February 5, 1981

Re: Sewer Connections to River Road Interceptor

PLAN

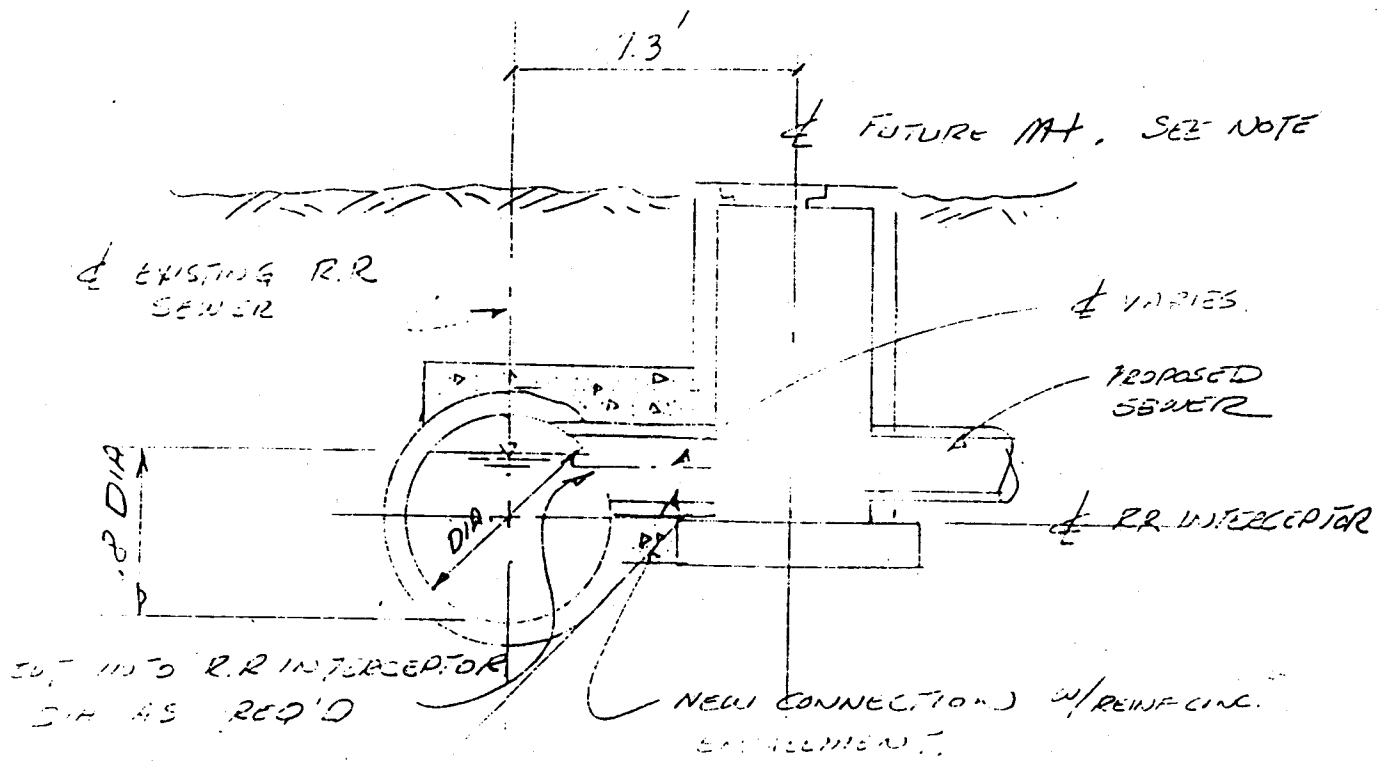
The other alternative is to allow a connection to the interceptor by breaking into the pipe either upstream or downstream of an existing manhole. I have attached a sketch drawing showing how that could be accomplished.

NOTE: FUTURE M.A. SHALL BE CONSTRUCTED WITHIN 7' OF ∅ RR INTERCEPTOR M.A., UP STREAM OR DOWNSTREAM OF EXITING M.A.
